COVERSHEET

Std. Hitch components - S40M

EC204U, EC206U, EC206BU/EC106, EC02U, EC05B, RFS40M, TFS40M

RELATED SPARE PARTS

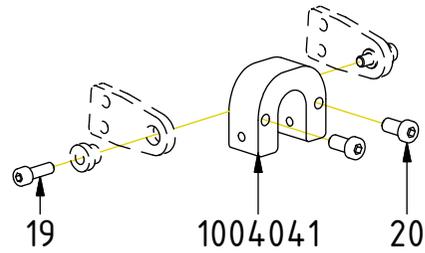
POS	DESCRIPTION	PART	QTY	COMMENTS
1	Shaft Mech. Lock	1004040	1	
7	Washer TBRSB FZB 8,4x26x5	611014	1	
8	Screw MC6S M8x20 12.9 ZFSHL	6000157	5	Loxeal 83-52 to POS.1
19	Screw MC6S M8x25 12.9 ZFSHL	6000143	2	
20	Screw MLC6S M10x20 8,8 FZB	610714	2	Loxeal 83-52
21	Weld the nut to the shaft		1	Procedure replaced by POS.7-8 from 2019-09

Replaced from 2026-02

Replaced from 2019-09

Replacing welding with current solution:
Shaft must also be replaced
